SECTION 00 91 13
ADDENDA

ADDENDUM:	<u>No. 2</u>
ADDENDUM DATE:	<u>August 26, 2024</u>
BID DATE:	<u>August 29, 2024</u>

This **ADDENDUM** is issued to institute the included changes and/or deletions to the Plans and Specifications for the **IFB# 026-45 HALL COUNTY-SPOUT SPRINGS WATER RECLAMATION FACILITY EXPANSION TO 1.6 MGD** project and hereby becomes a part of said Plans and Specifications.

EXHIBIT 2

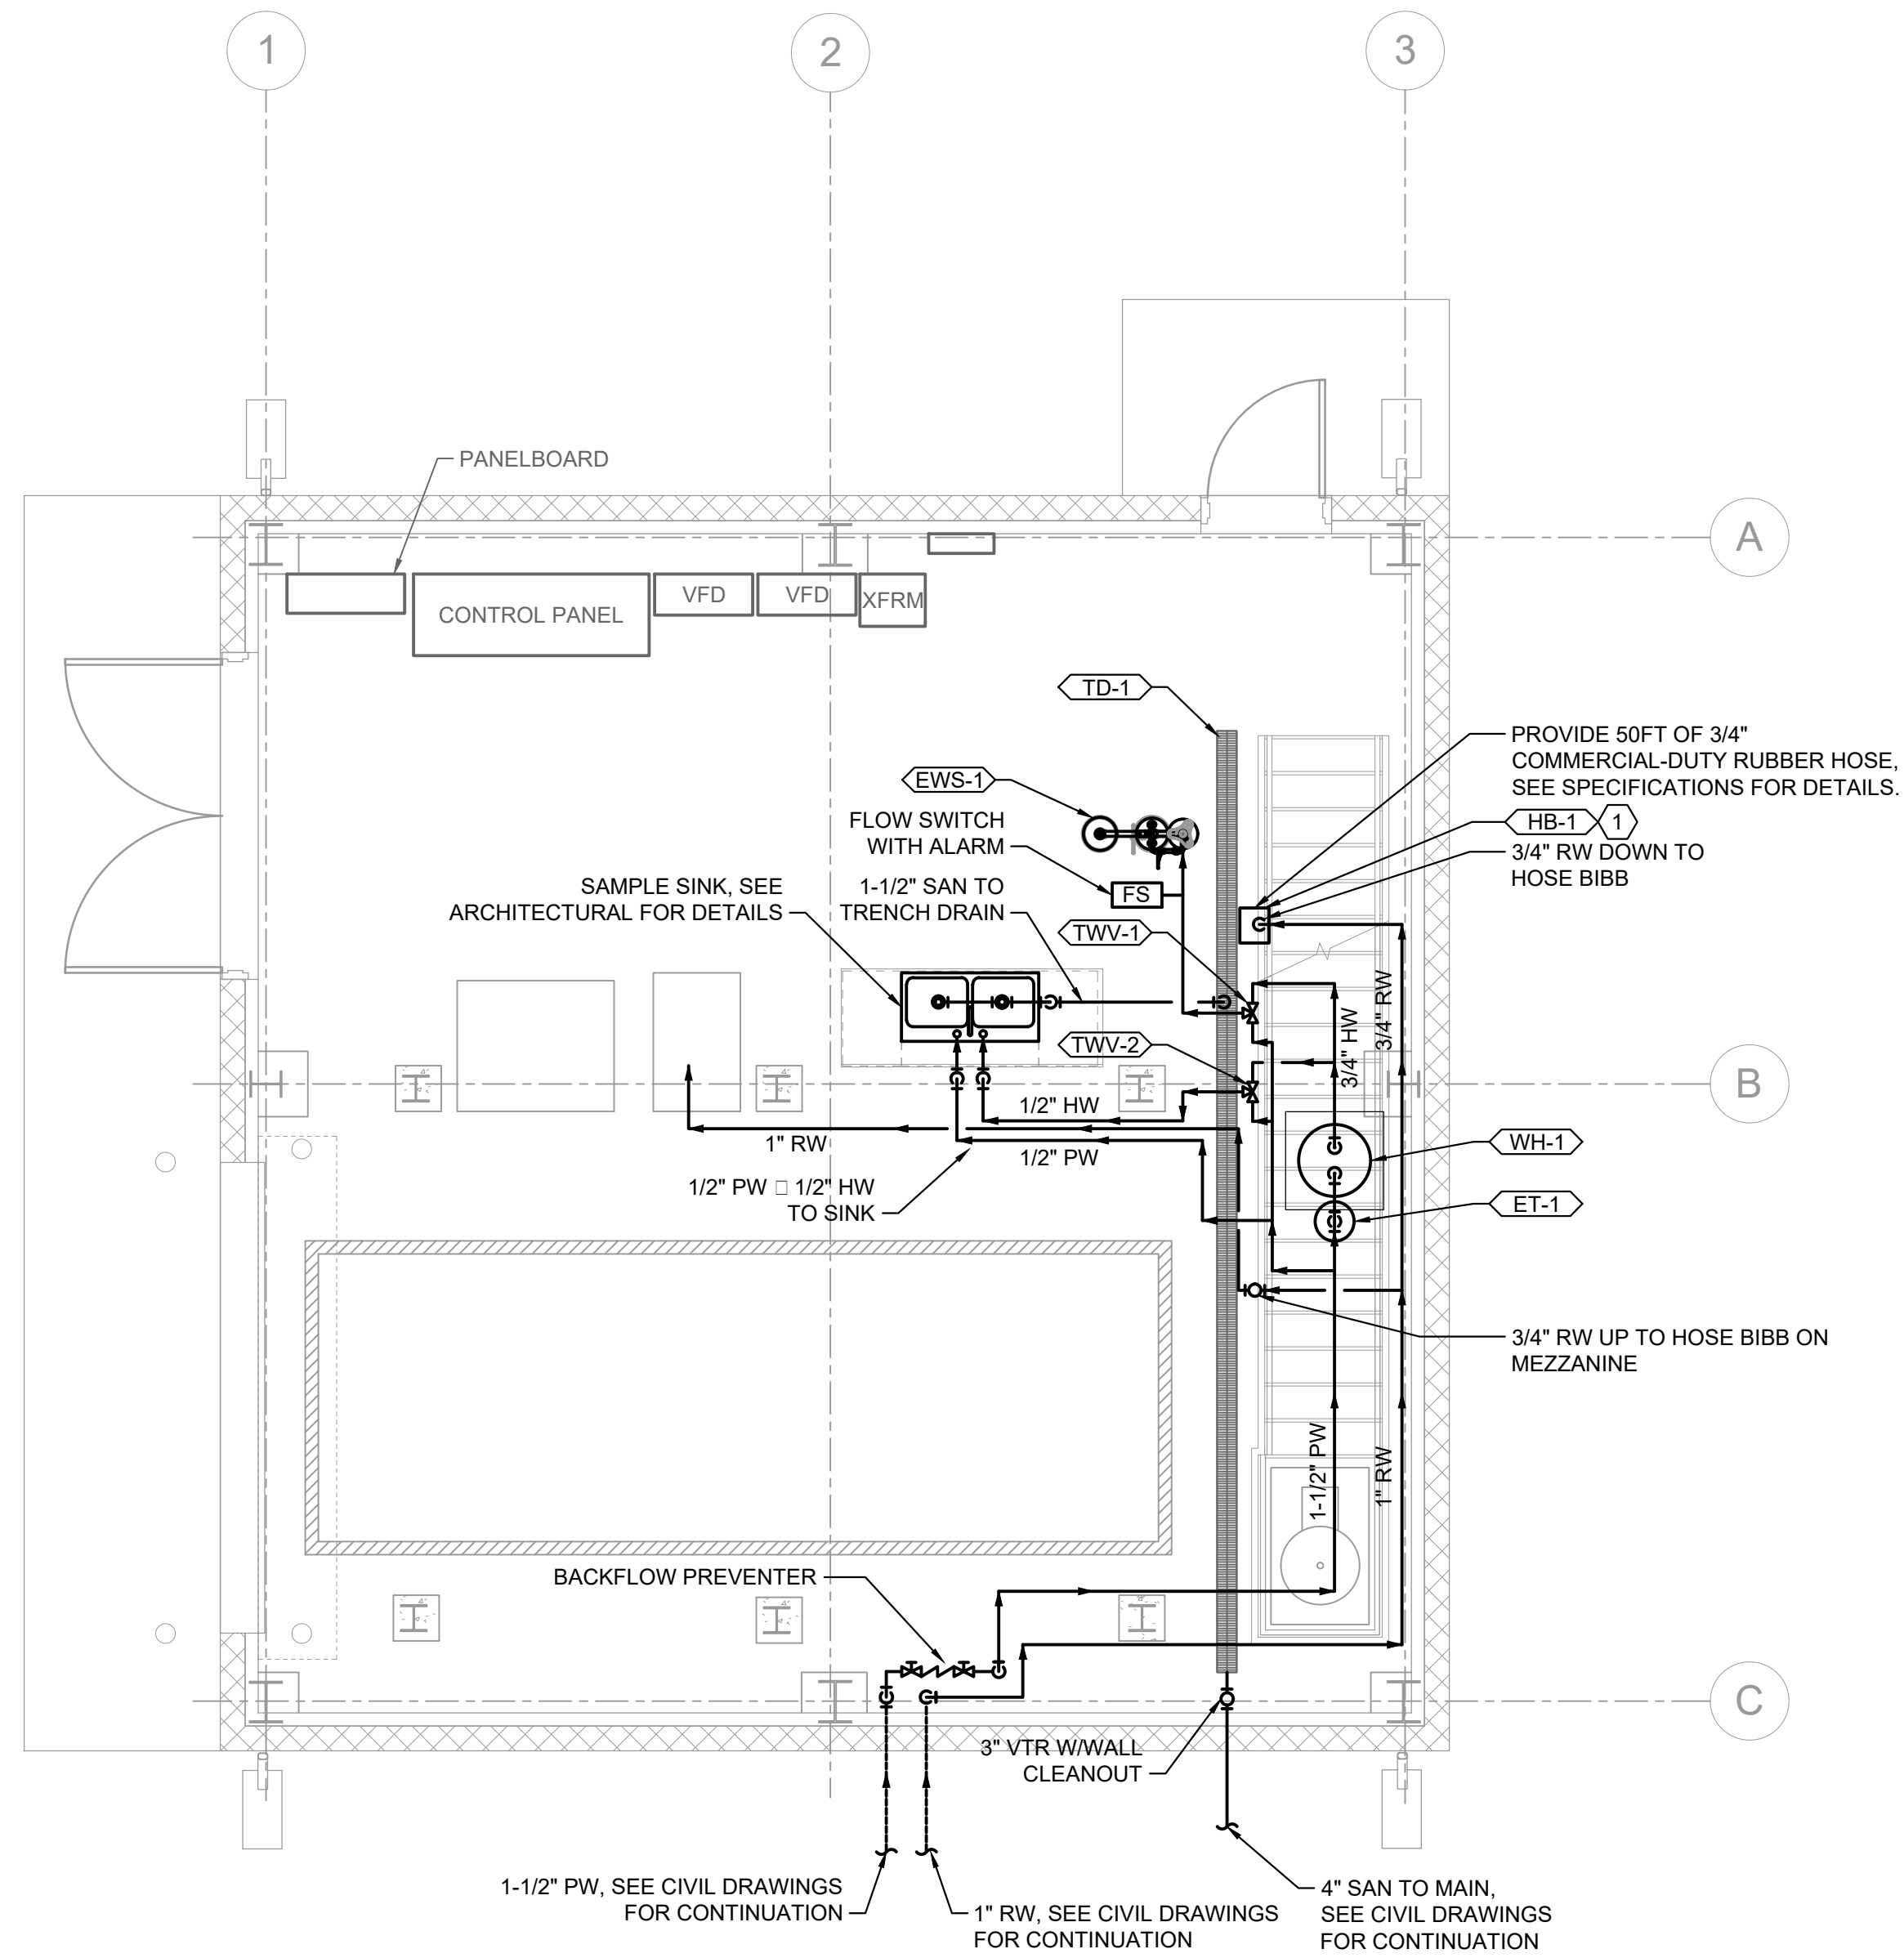
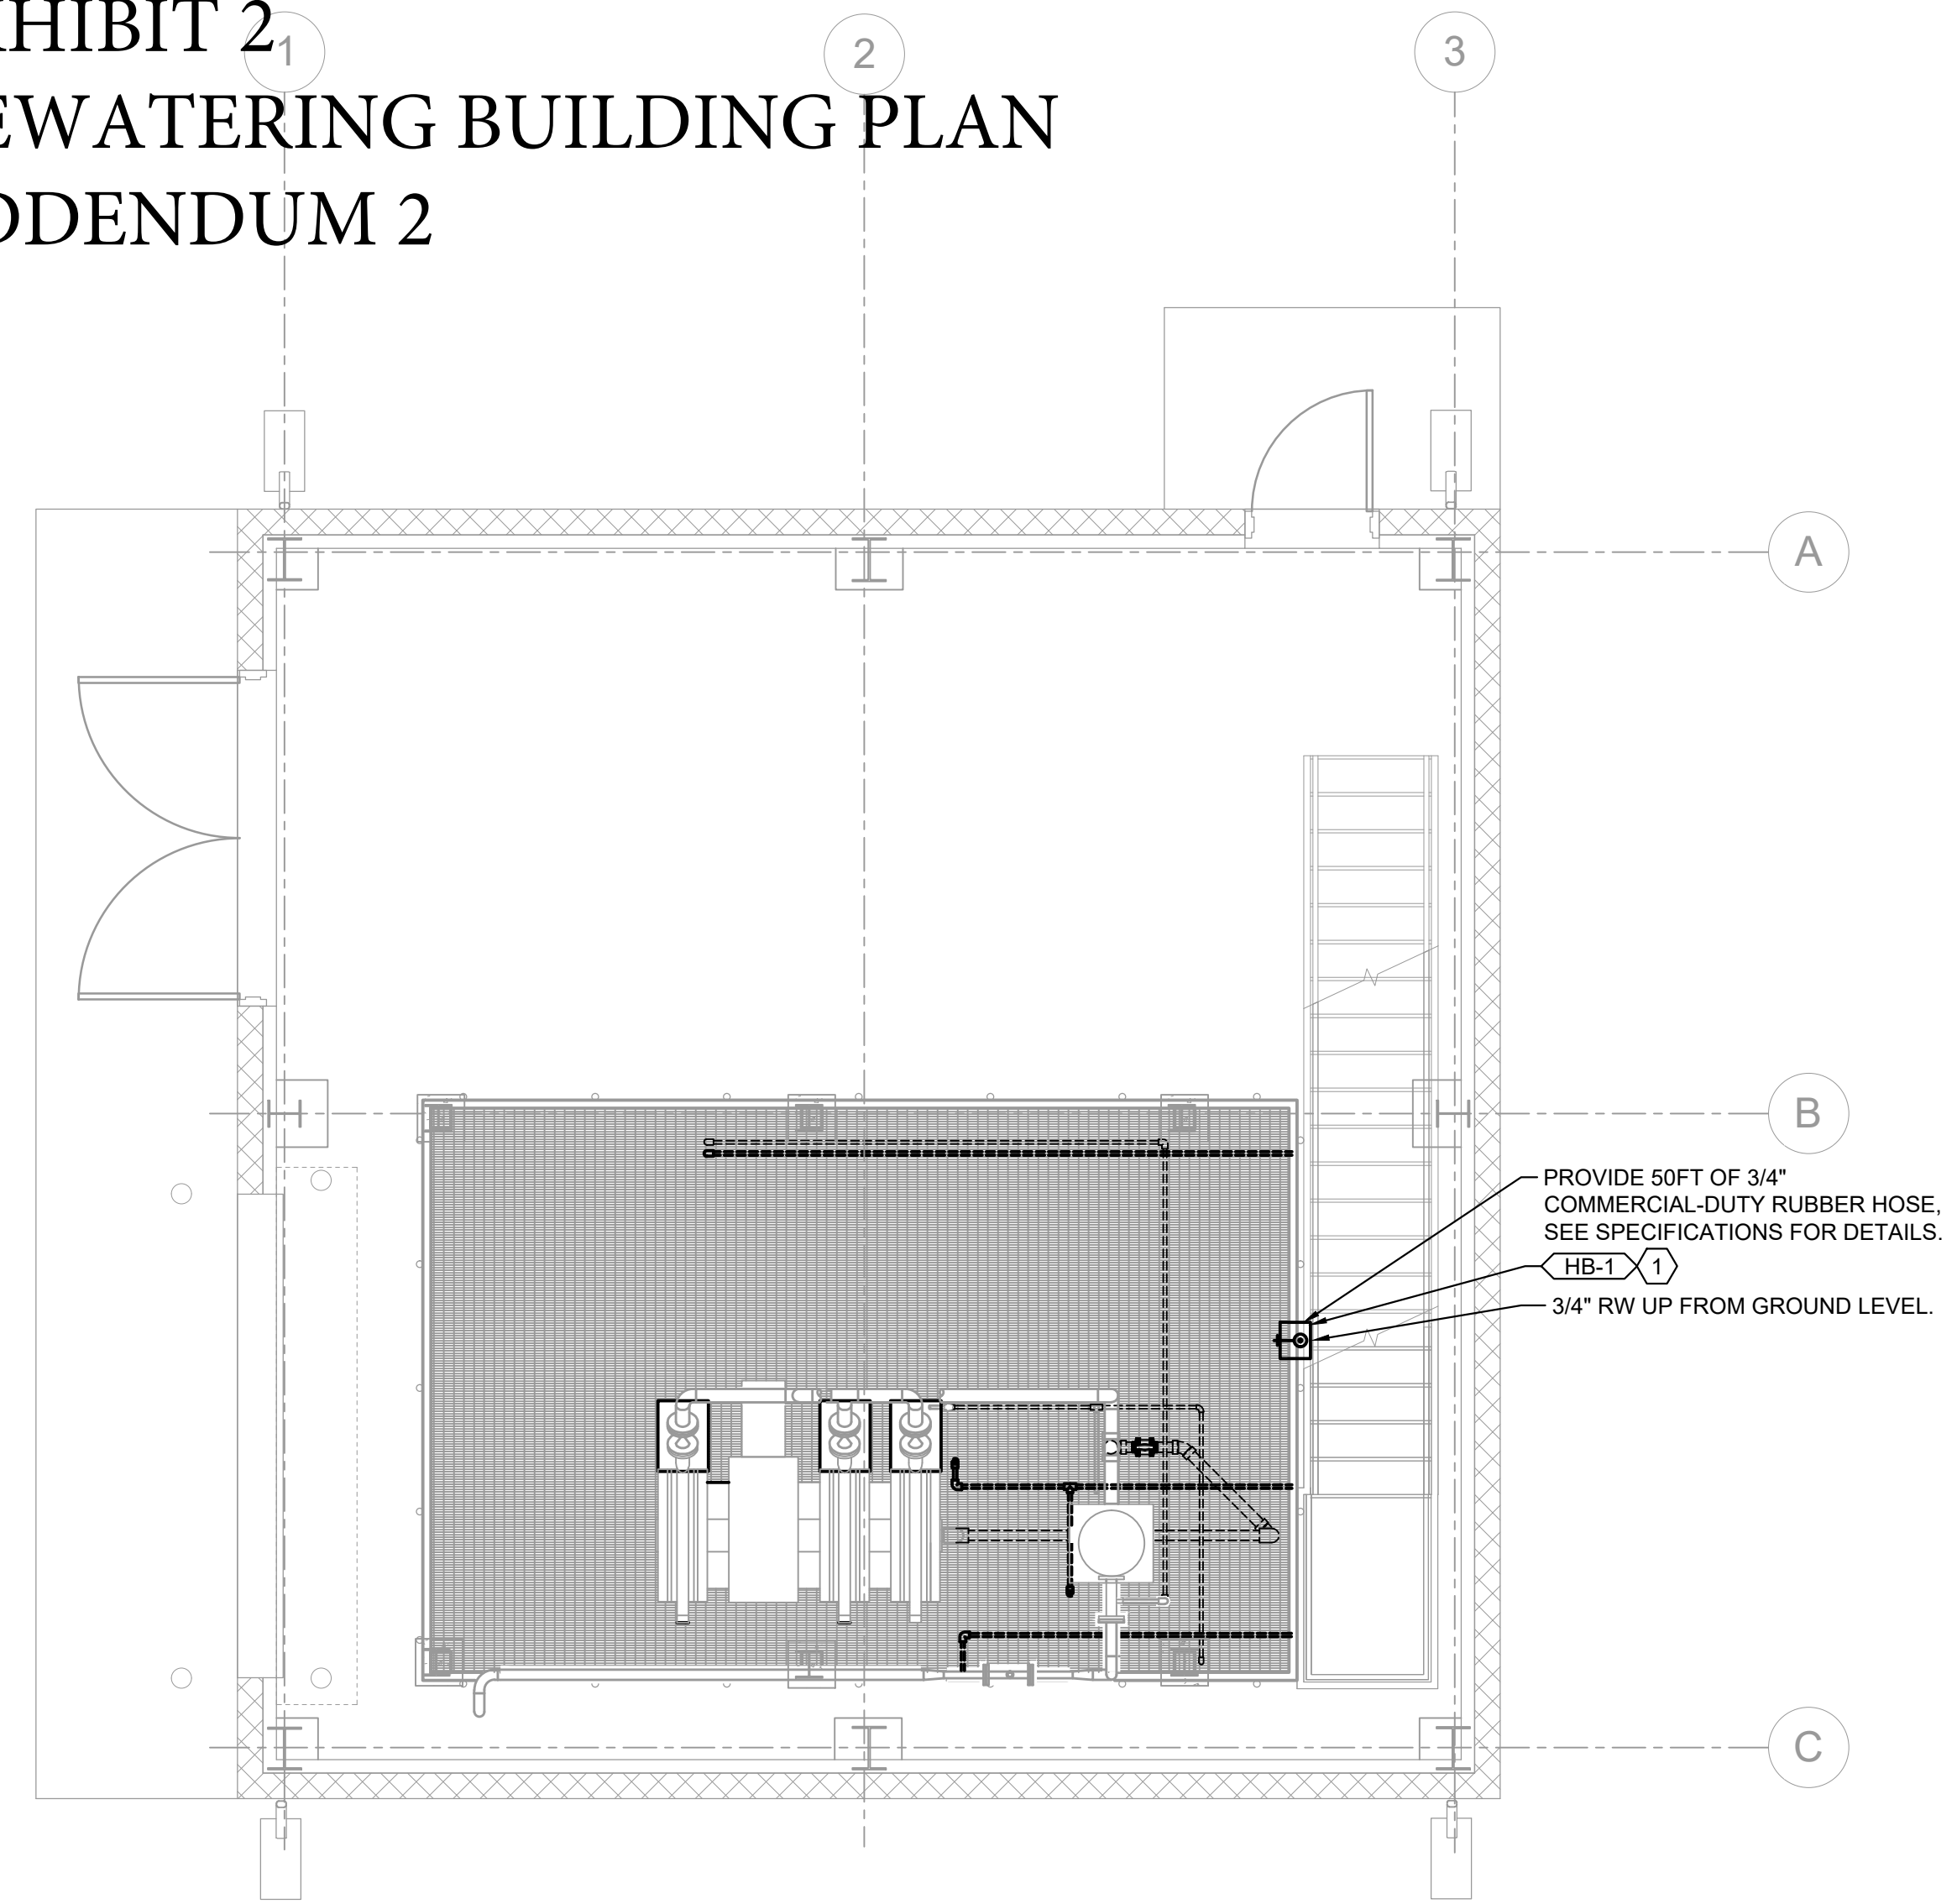
23. Drawing 3-C-5A shows a 2-½” Potable Water to Dewatering Building, but there are no drawings showing what happens to the piping after it approaches the building envelope. Please provide additional drawings/details on where the pipe goes/connects.

Connect the new piping to the existing piping outside the building footprint. Field locate the existing piping. See exhibit 2 for best available information. Also refer to Drawing 11-M-4. Exhibit 2 is for information only and not considered part of the Contract Documents.
